# WELCOME to the Iditarod Dog Sledding Historic District (IDSHD) Workshop

January 11, 2012

Houston Middle School  
Houston, Alaska

Revised Historic Iditarod Crossing design following the IDSHD Workshops

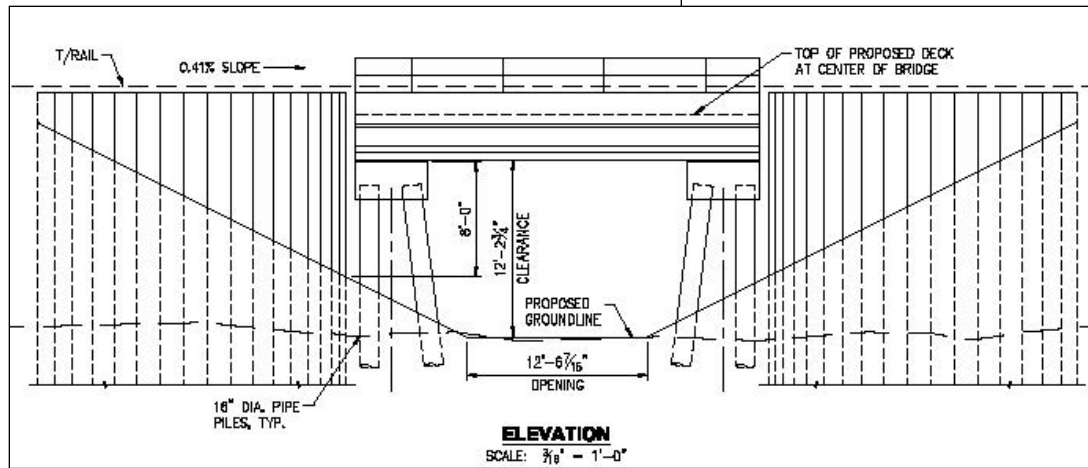
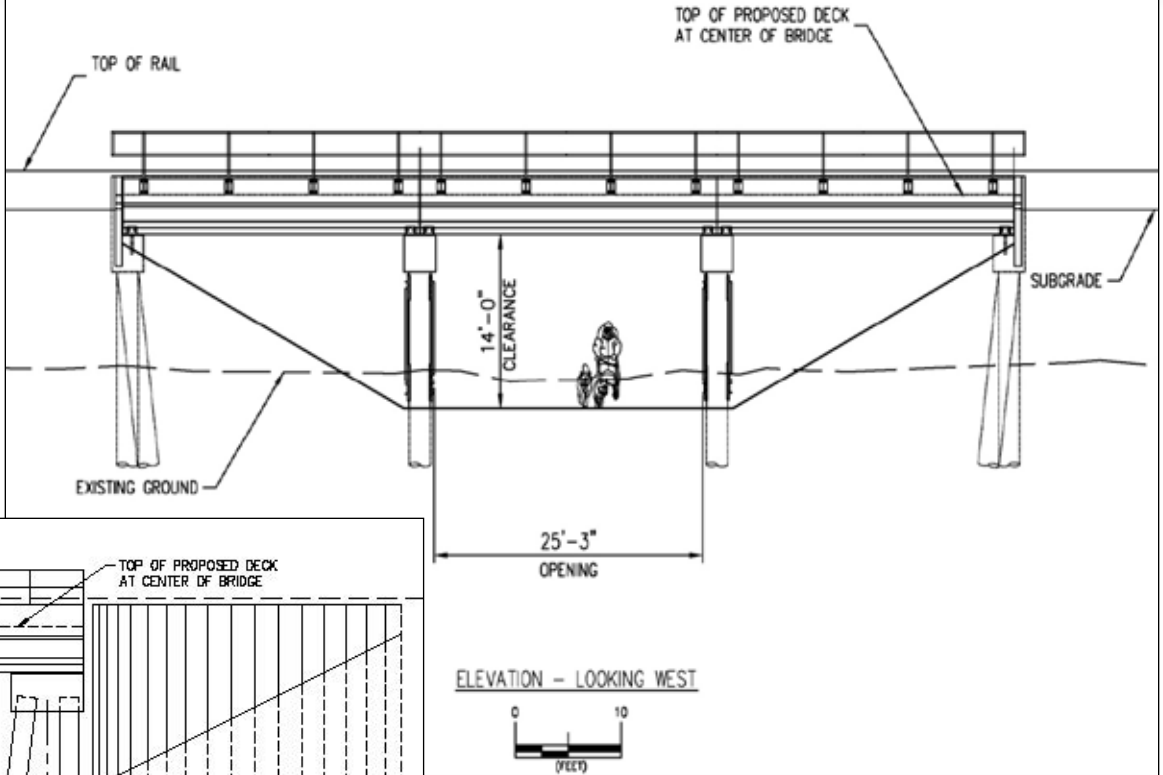
The height (vertical clearance) of crossings needs to be increased to more than 12' to account for snow depth, accommodate equipment for grooming of trails, and enhance safety. The existing clearance is as low as 10' for some crossings.

Vertical clearance increased to a minimum of 14' whenever possible

Approach example

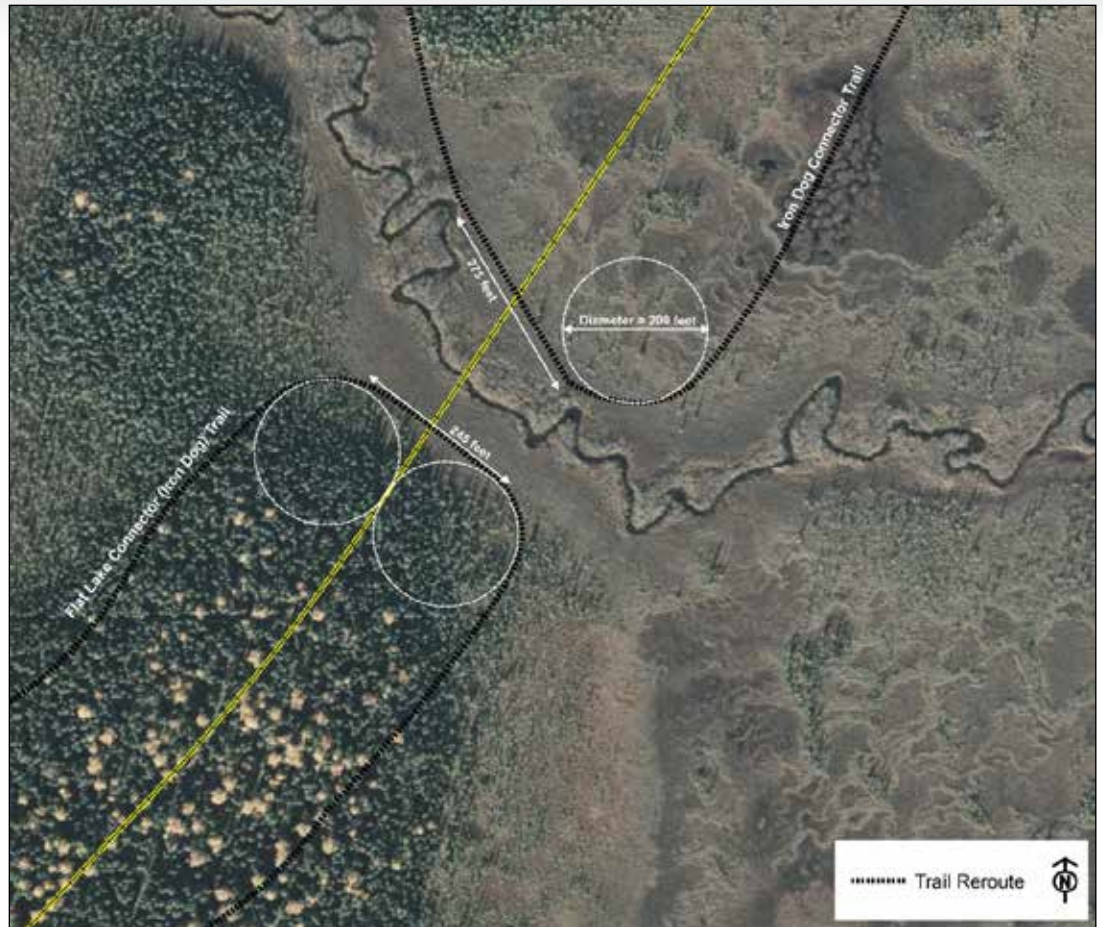
The length of a sled dog team with 16 to 20 dogs (approximately 85') needs to be considered during design of trail approaches to crossings to ensure curves are not too tight. (This comment was made in reference to the rerouted trails, specifically Crossing H 6.3 [Project Crossing 5]).

Design standard for approaches:

- Gentle curves - turn radii between 75' and 90'
- Allow 100' long dog team to turn and safely pass through the structure
- Allow adequate line of sight.

# Line of Sight

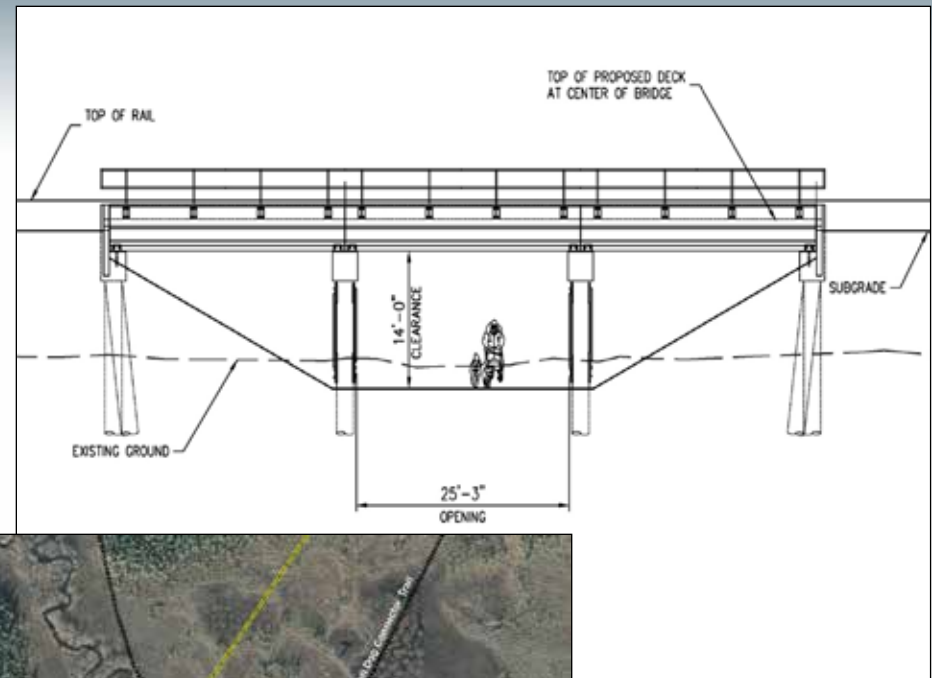
Some crossings are single span bridges and do not provide mushers with adequate visibility to see if anything is approaching from the other direction. The length of these crossings needs to be increased. Trail approaches to crossings also need adequate line-of-sight.

Redesigned bridges:

- Minimum of 3-spans
- Generally provide 20' horizontal clearance (minimum)
- Adequate line-of-sight provided by relatively straight approaches

# Constraints

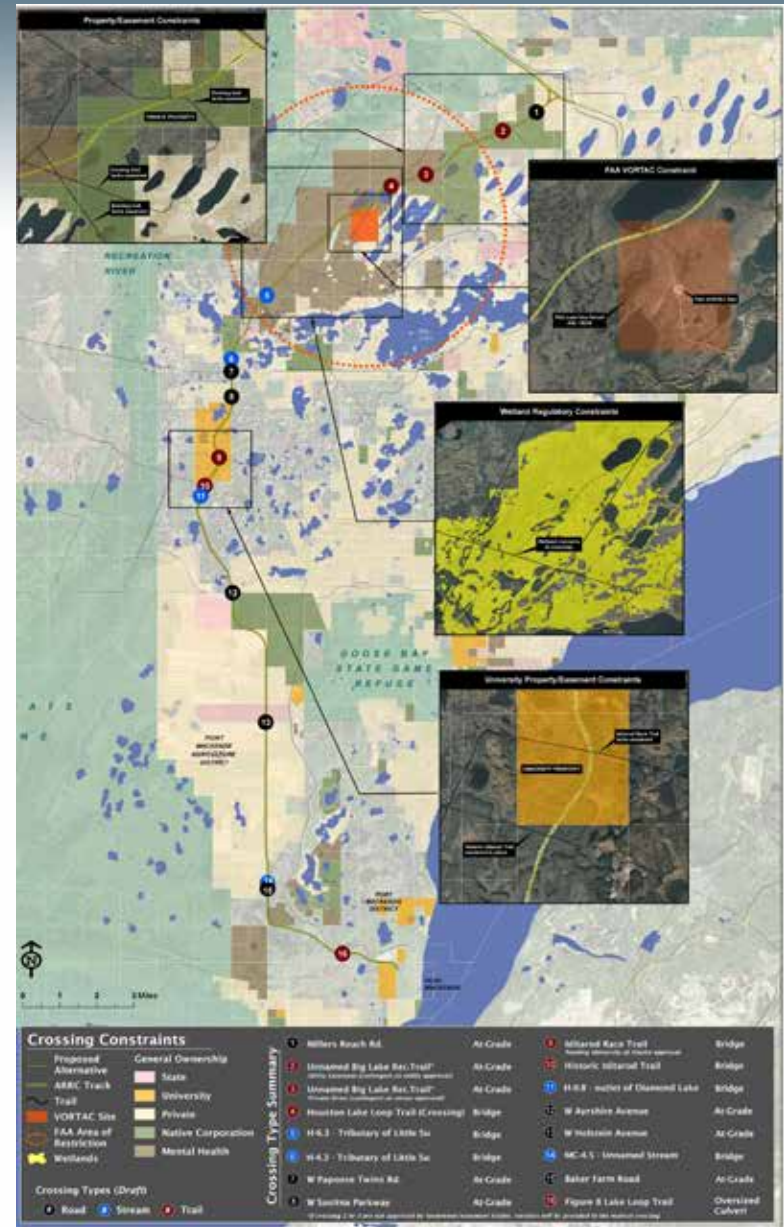
Provide a map to workshop participants showing where crossings cannot be located (e.g., VORTAC or wetland restrictions or other design concerns).

The constraints map (right) is:

- Posted on the Project website
- Included in the comment summary document
- Presented at workshops/open house

- FAA VORTAC radar site (3 mile radius)
- Wetlands
- Land ownership
- Lack of legal easements

# Iron Dog Connector

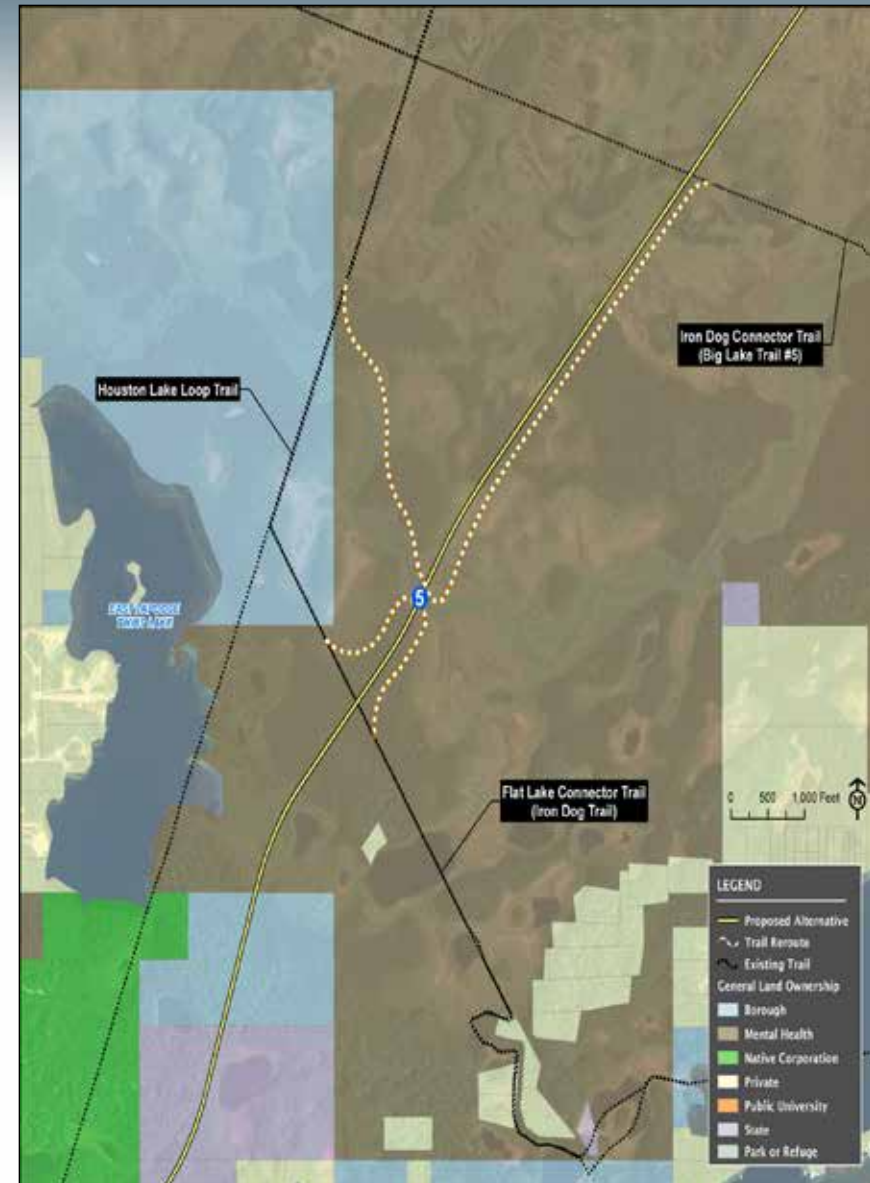
Provide a crossing for the Iron Dog Connector Trail (Big Lake Trail #5 in MSB Trails Plan).

- Propose a reroute of trail
- A crossing is not a good option at this location due to:
  - Safety concerns
  - Wetland/regulatory concerns
  - Tree cover and topography
- Project Team working with the following regarding the rerouted trail:
  - MHLT to acquire easements
  - Iron Dog Race Board of Directors

Crossing 5 (H 6.3) profile view.

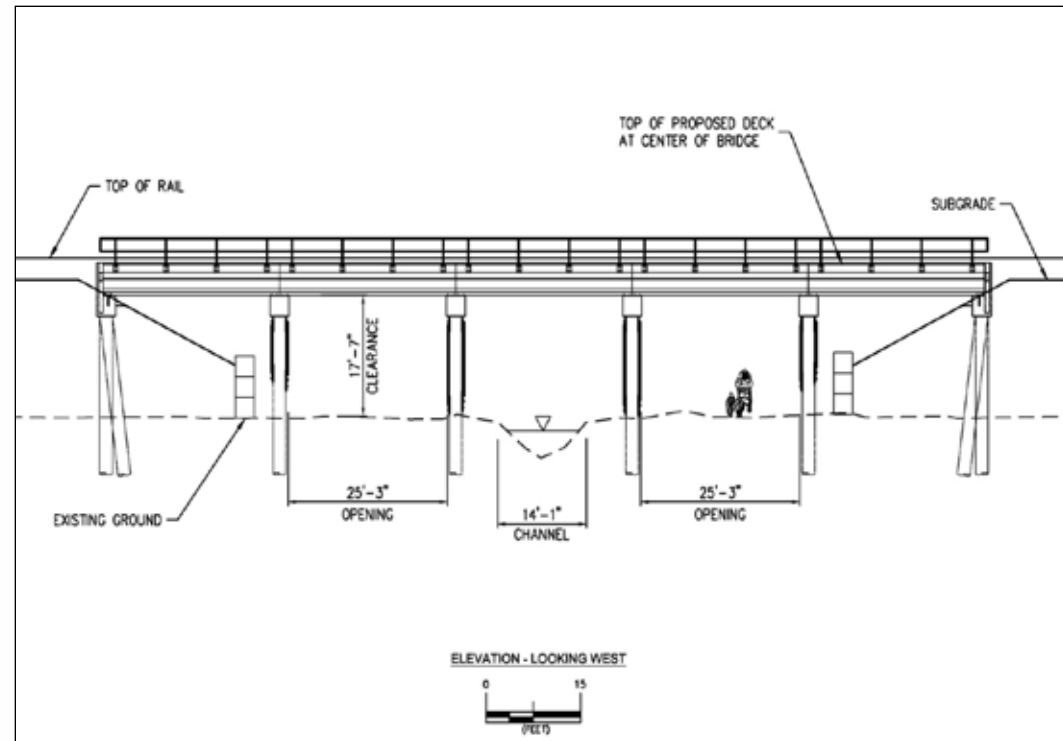
Incorporate safety considerations into design for the Houston 6.3 crossing (Crossing 5). Design should account for increased traffic caused by funneling multiple trails into a single crossing and should include wider/higher openings under the bridge, a wider turn radius for the reroutes approaching the crossing location, and a good line of sight approaching and extending under the crossing.

The improved structure will provide:

- Trail on both the north and south side of the creek
- 25'+ horizontal clearance to accommodate multiple users and grooming equipment
- 17'+ vertical clearance
- Sufficient line-of-sight
- Approaches with gentle curves (75'-90' radii)

# Iditarod Race Trail

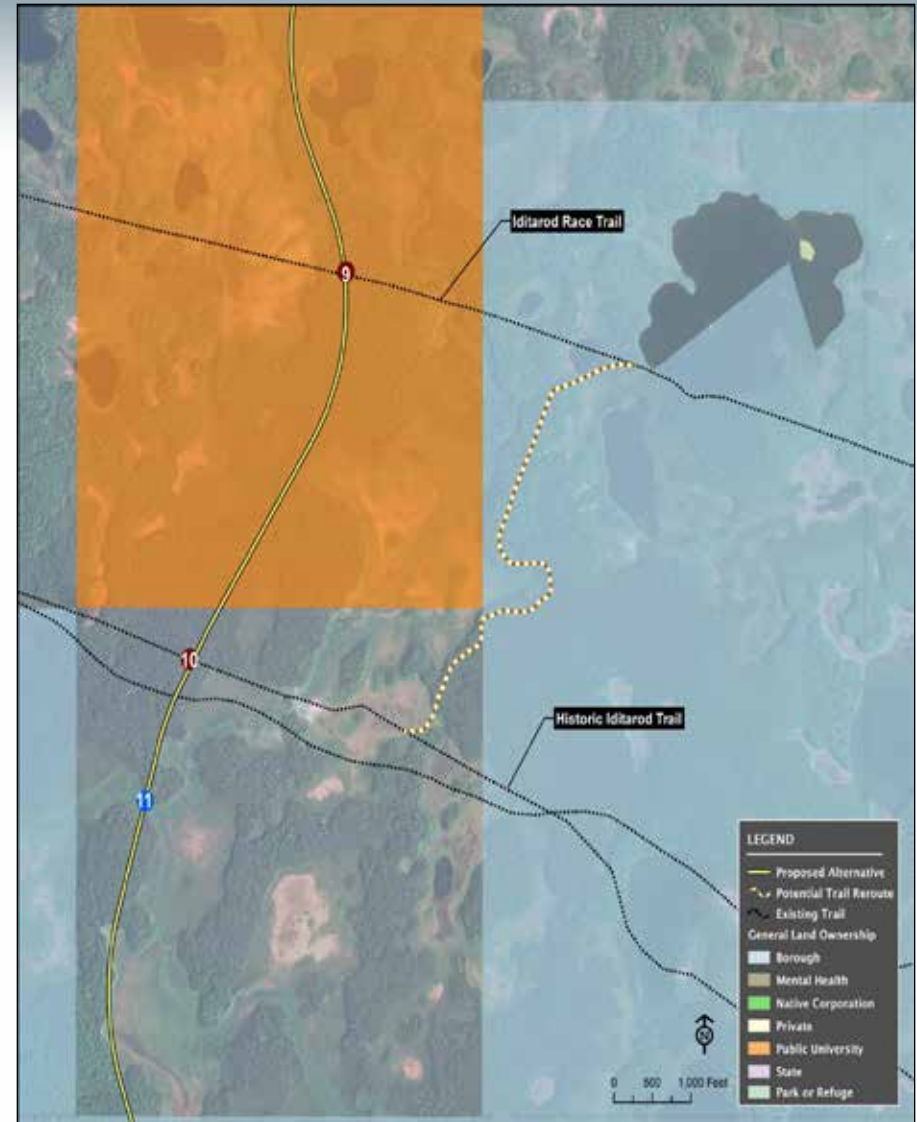
Provide a crossing for the Iditarod Race Trail and obtain an easement from the University of Alaska for this trail should one not currently exist. This trail has reportedly hosted 20 Iditarod races and is used more frequently/regularly than the Historic Iditarod Trail. A separated grade crossing (bridge) is preferred, but if a bridge is not possible, an at-grade crossing would be better than no crossing at all.

- MSB is working with UA to secure an easement at this location
- If easement secured, crossing would include:
  - Typical three-span bridge
  - Minimum 14' vertical clearance
  - Approximately 25' of horizontal clearance (center span)
  - Approach improvements
- Reroute to Historic Iditarod Trail if easement cannot be secured

# Additional Crossing

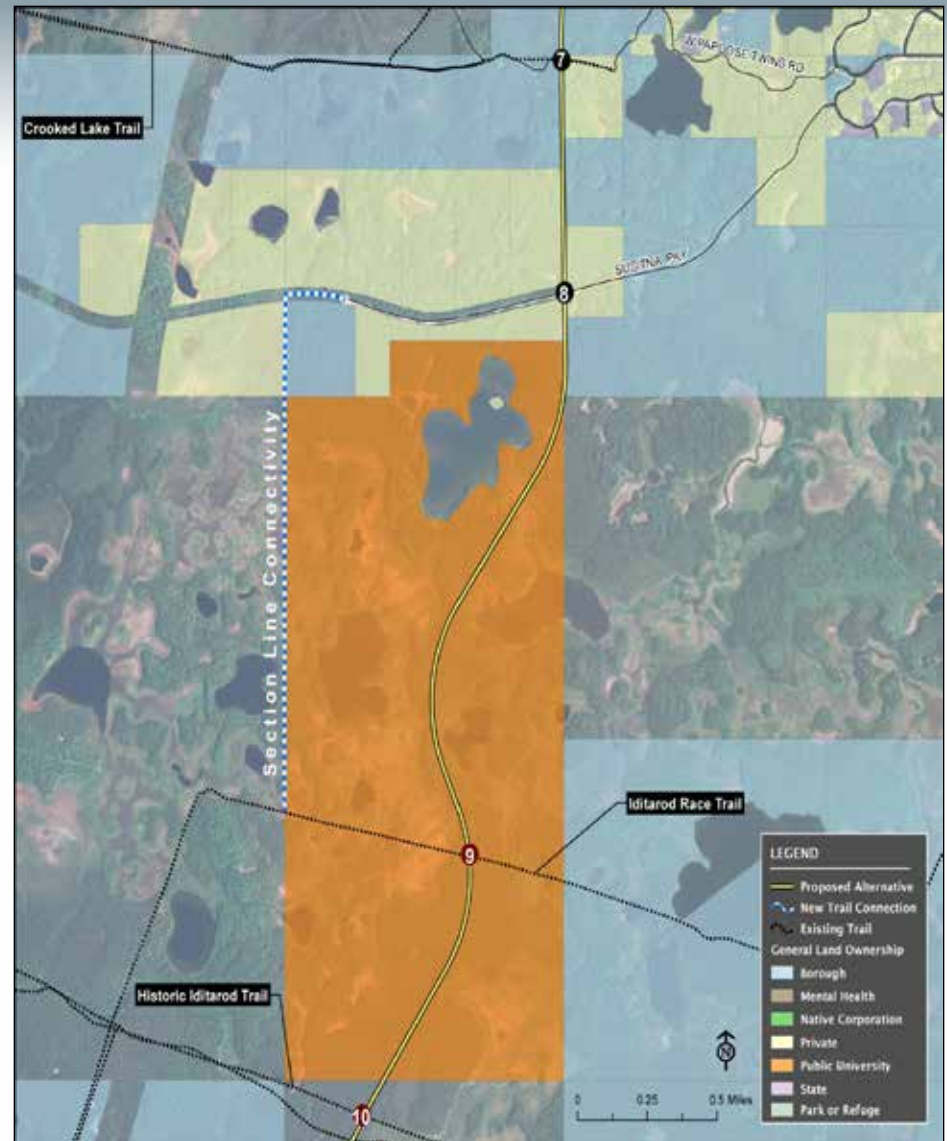
Add a crossing for the trail between current Crossings 12 and 13 (formerly Crossings 13 and 14) that is shown on various maps.

- Although it appears on old maps, this former trail is on agricultural land and is no longer used.
- Per consultation with Workshop/Open House participants, this crossing is not needed
- No crossing is proposed in this location
- Baker Farm Road at-grade crossing (Crossing 14) has been added to Project maps

# Signage

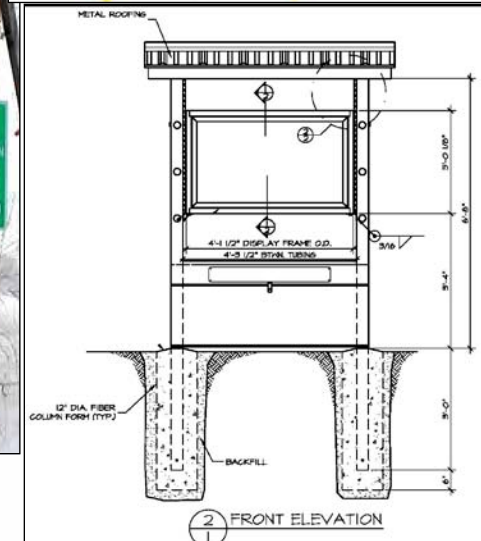
Adequate signage needs to be provided to warn trail users. Consider standard snow machine/dog sledding trail signage as seen on Alaska State Parks Snowmobile Trail Advisory Committee (SnoTRAC) website, not road side signs.

- Appropriate signage placed at key points on trails, trail reroutes, and crossings
- Project Team will develop signage that is consistent with the Alaska State Parks SnoTRAC guidelines
- Kiosks with trail maps placed at key locations to aid users by identifying trail reroutes and connections
